**ADDENDUM NO. 3**

Date: August 21, 2023

**Project: Project #: 0146-465  
0146-465 Isador Cohen ES / Rosemont HS Security Improvements: Group 1**

SHEET NO.  
**C2.1**

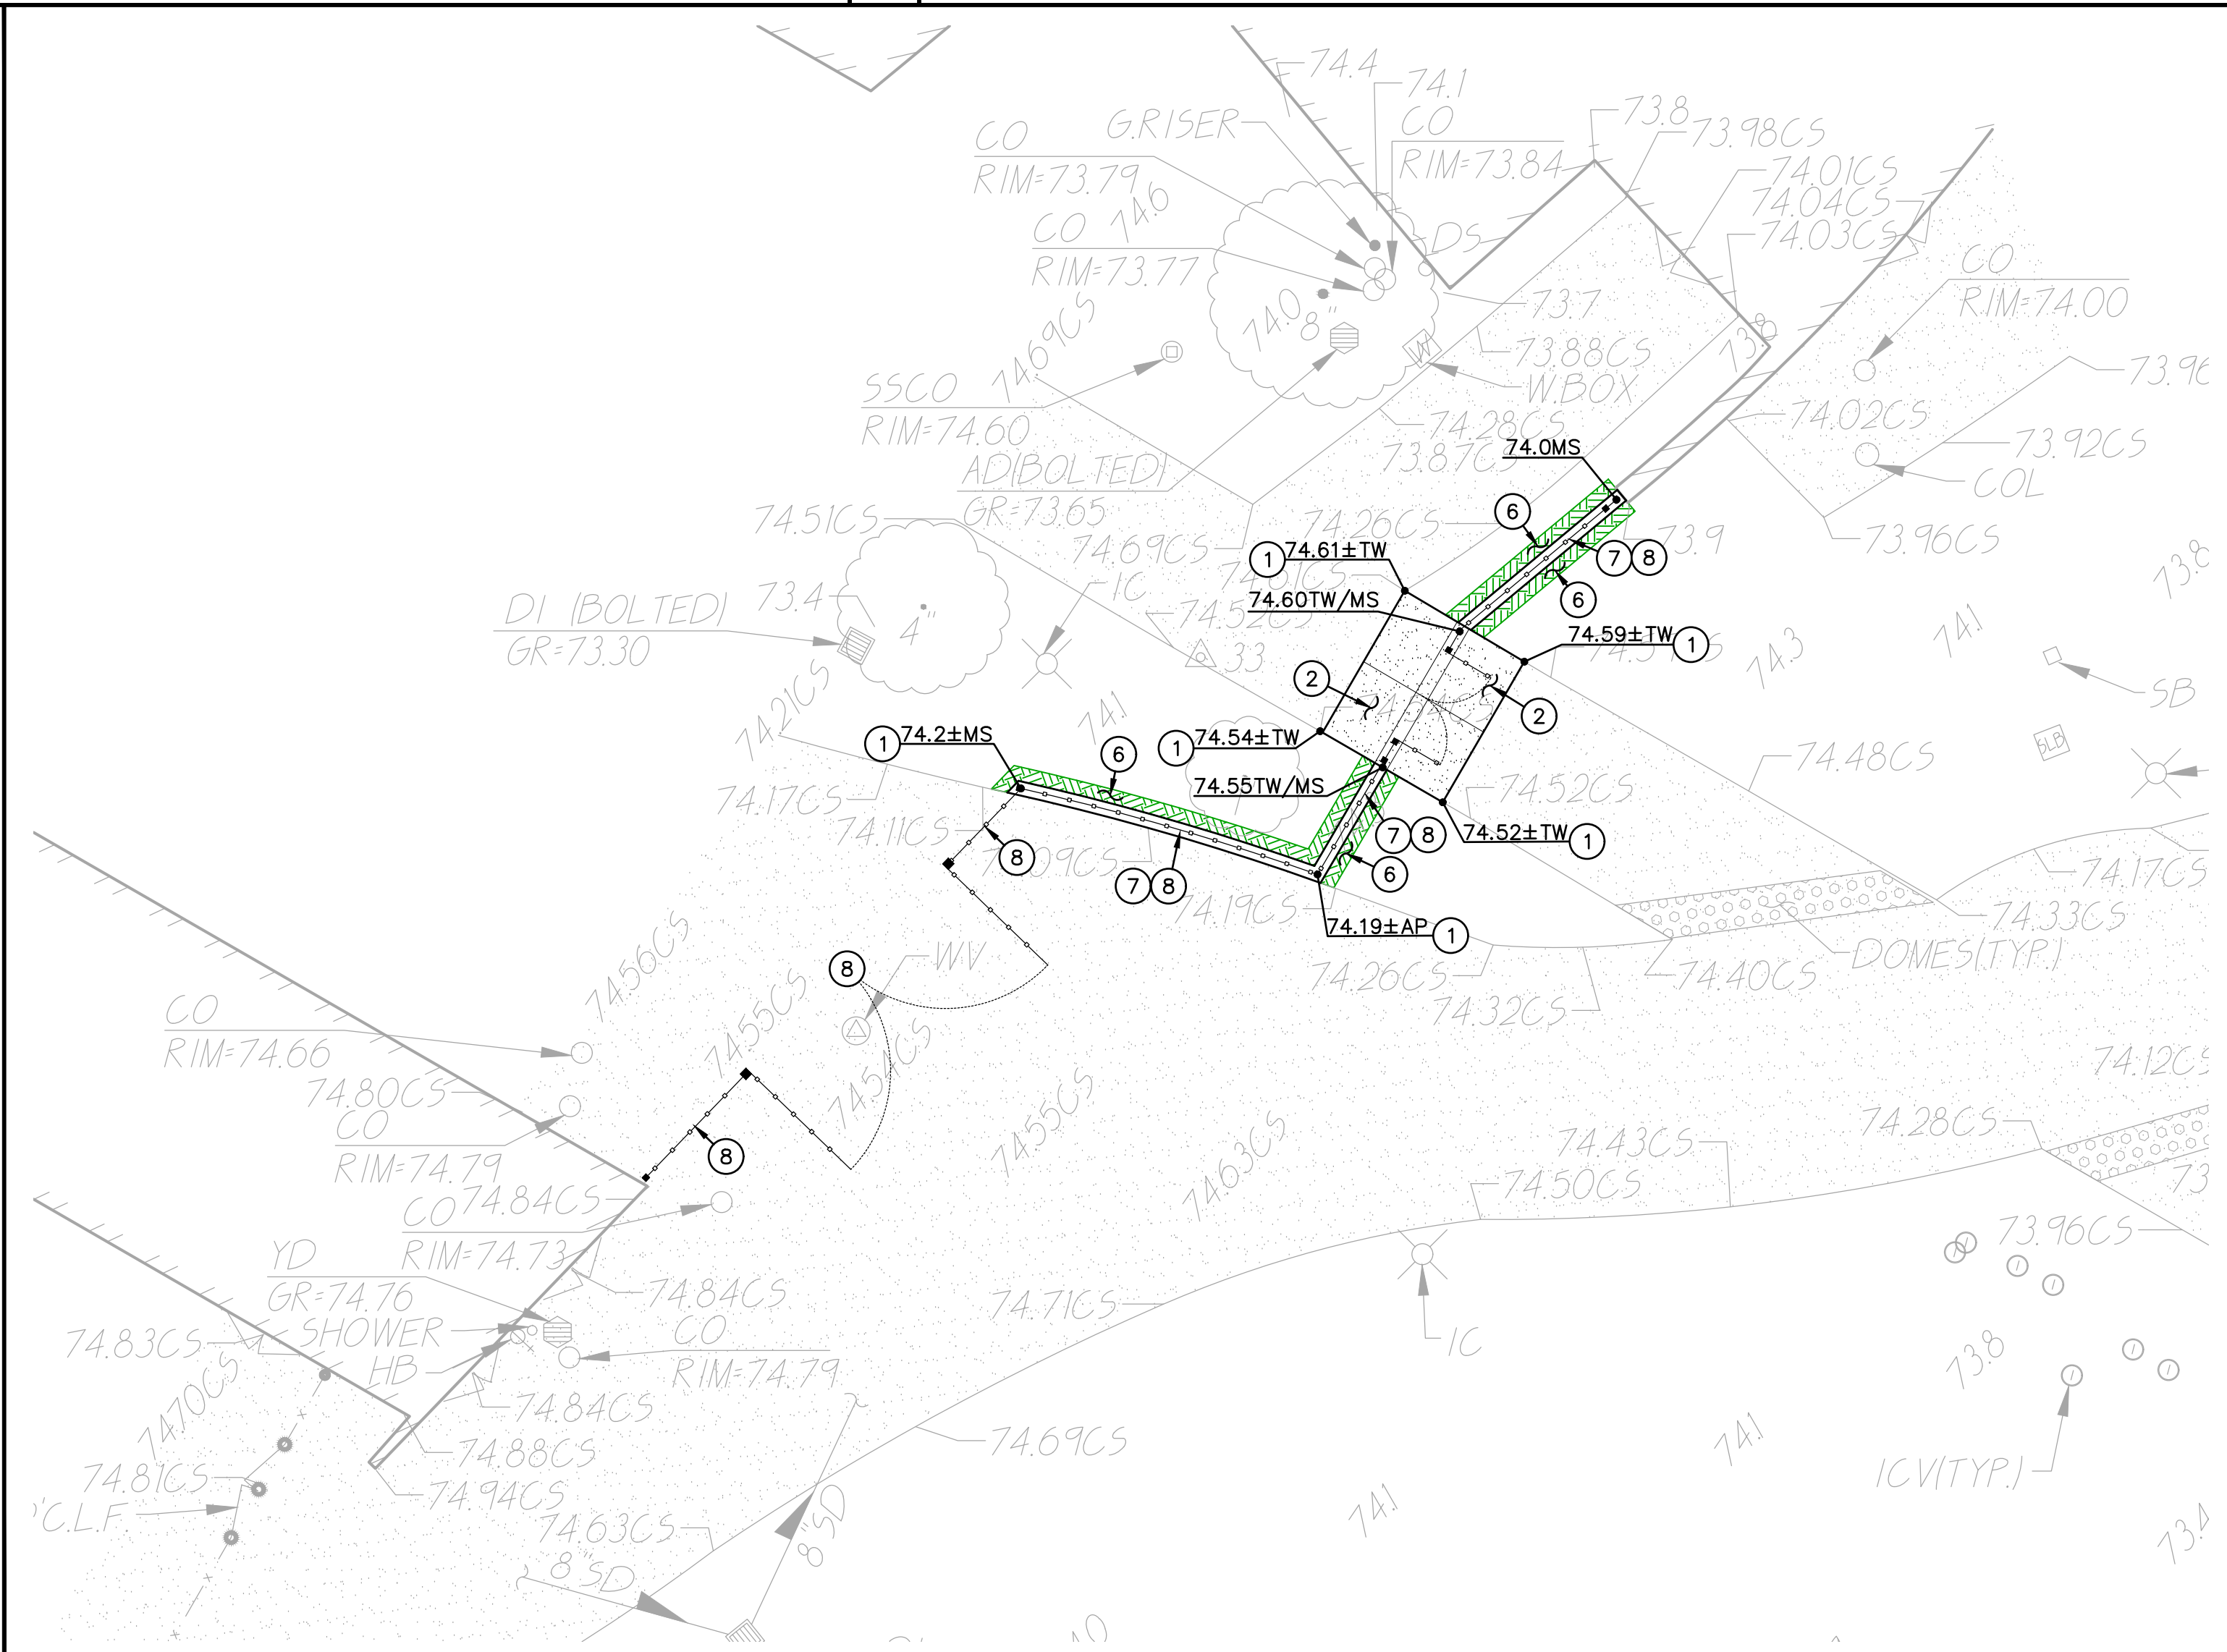
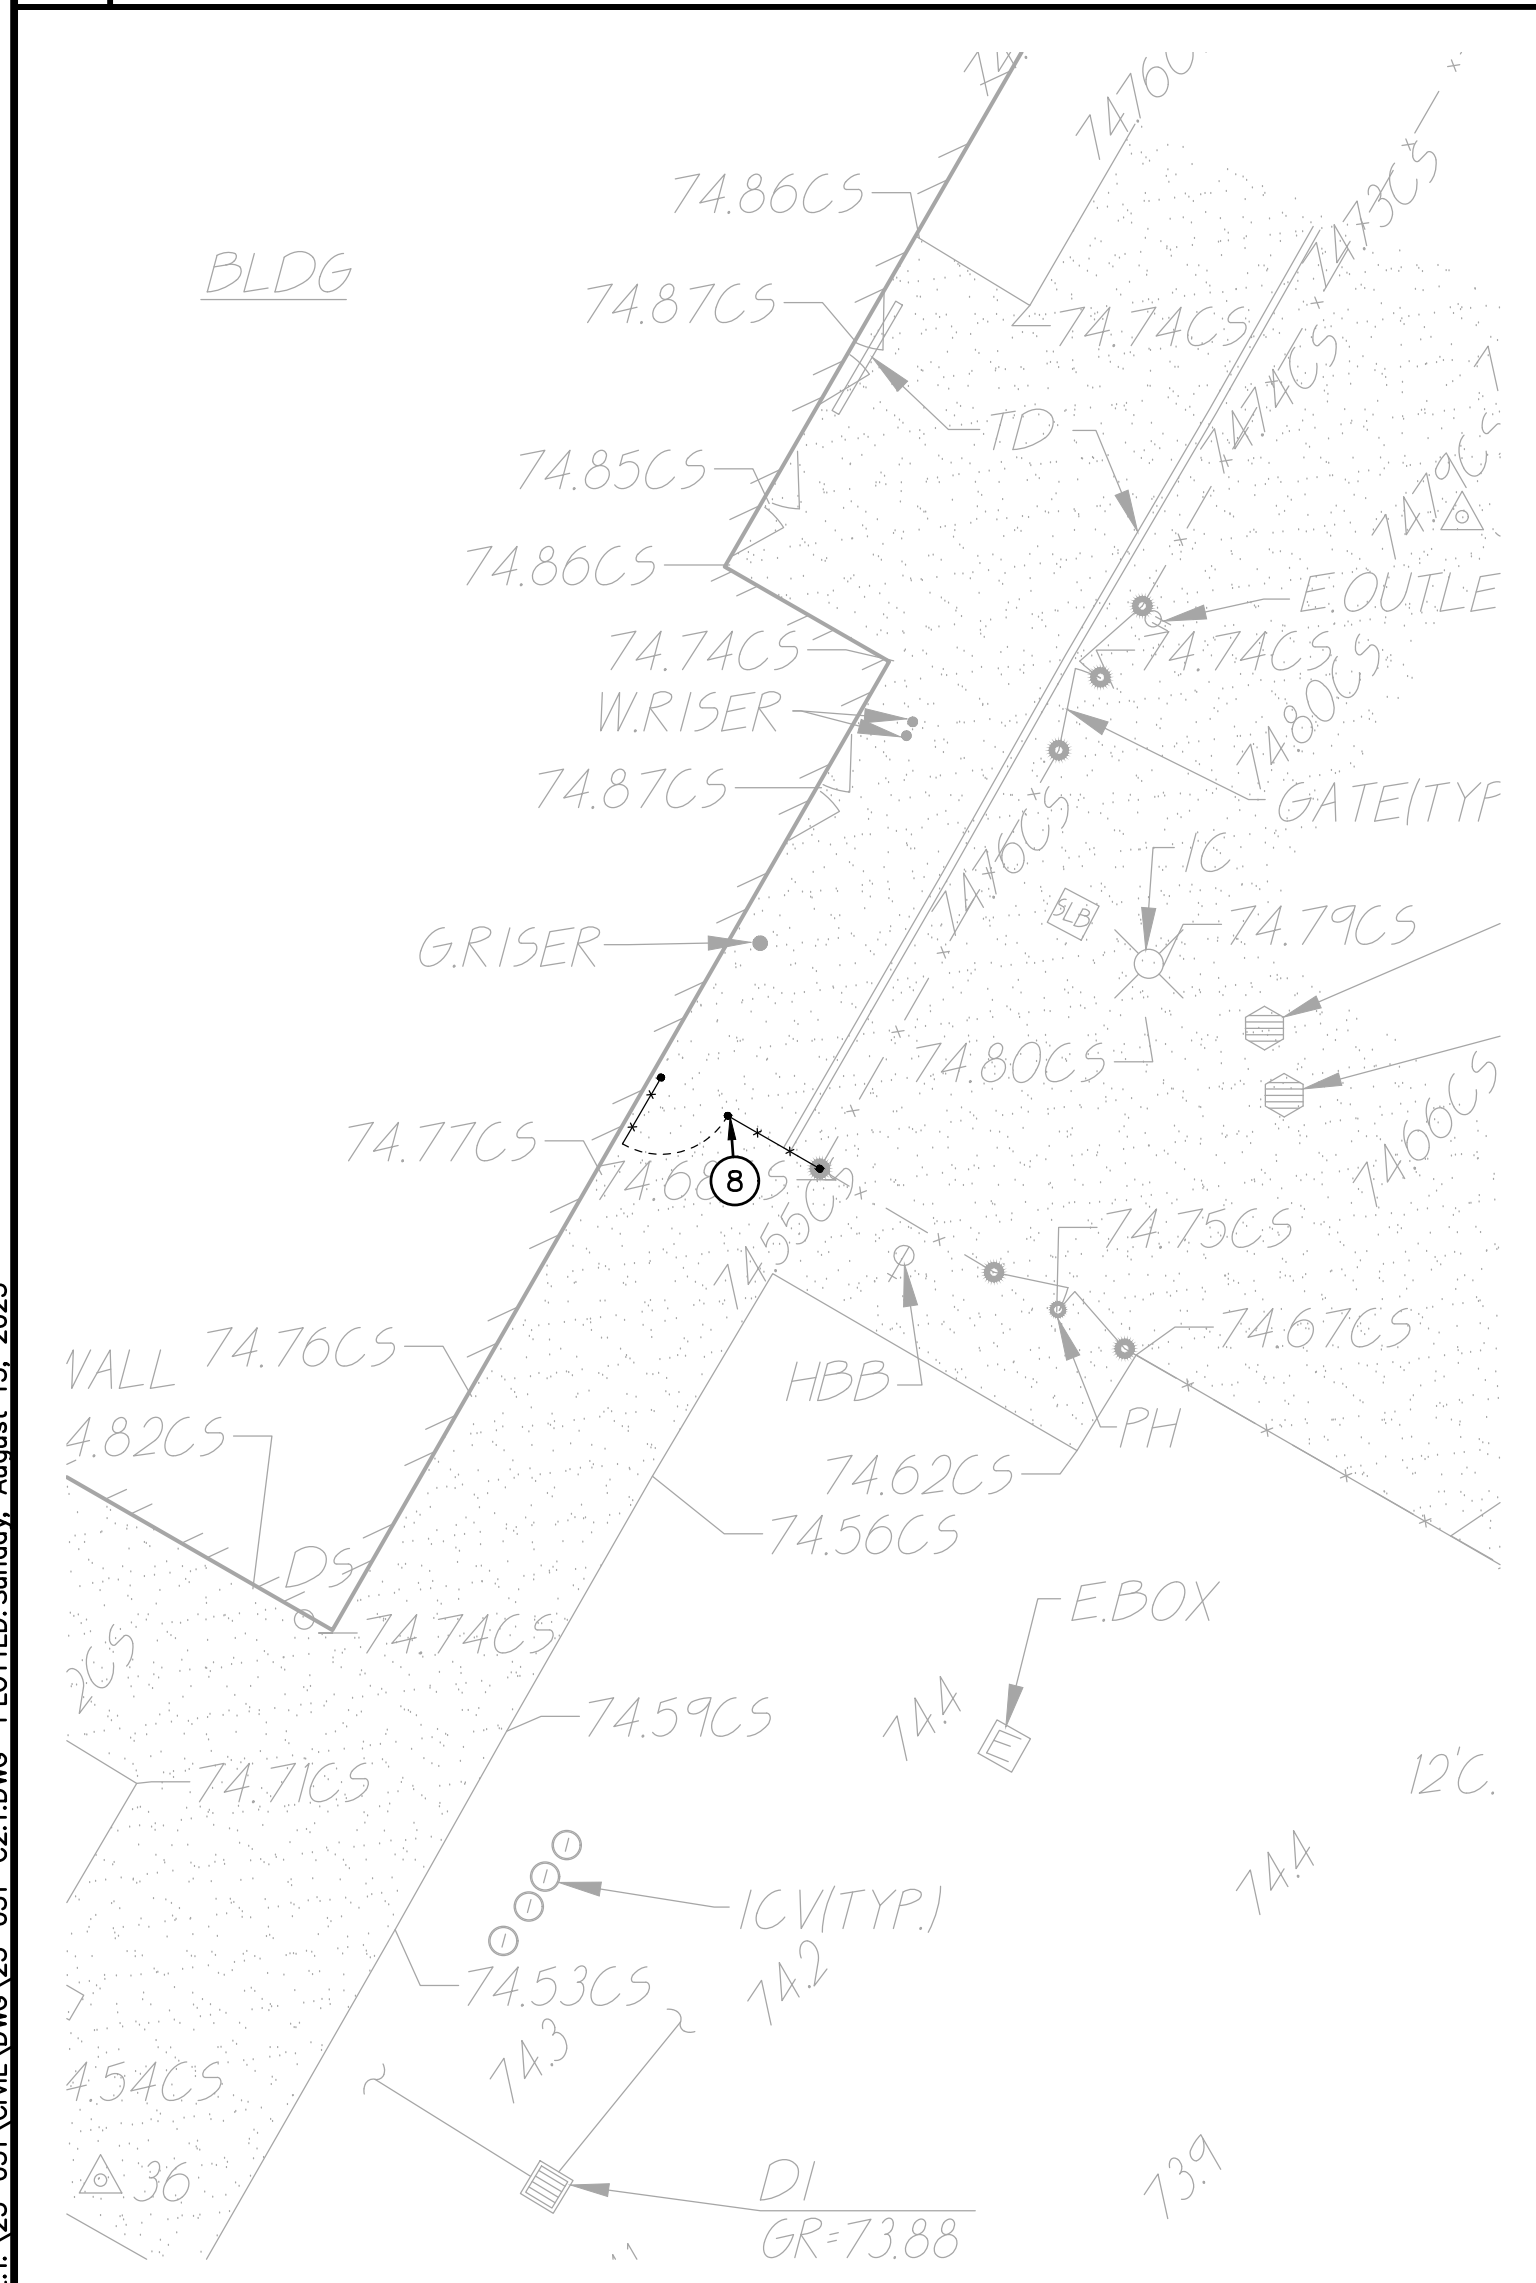
**Sheet C2.1**

- Additional flatwork shown in view 2 near north most gate.
- Surface repair general note added.
